NON COMPLIANCE RECALL

Date	Number	Release	Page
04.2023	EC0024	02	1(4)

**Mack Vehicle Emission Label
AN, GR, LR, MD, PI, TE**

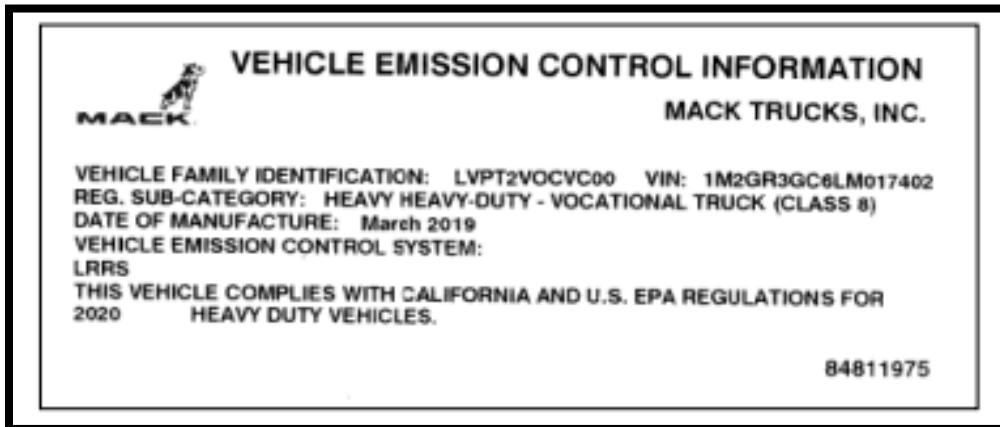
Some Mack model trucks will receive six driver's door labels as a packet. Do not install all six labels. Only install the VEHICLE EMISSION CONTROL INFORMATION label (shown below). The other unused labels MUST be destroyed.

1. Secure vehicle for service.
2. Place the transmission in park or neutral.
3. Install wheel chocks.
4. Open the driver's door.
5. Use a plastic scraper and adhesive remover to remove the old vehicle emission label.
6. Install the new vehicle emission label in the door jam.
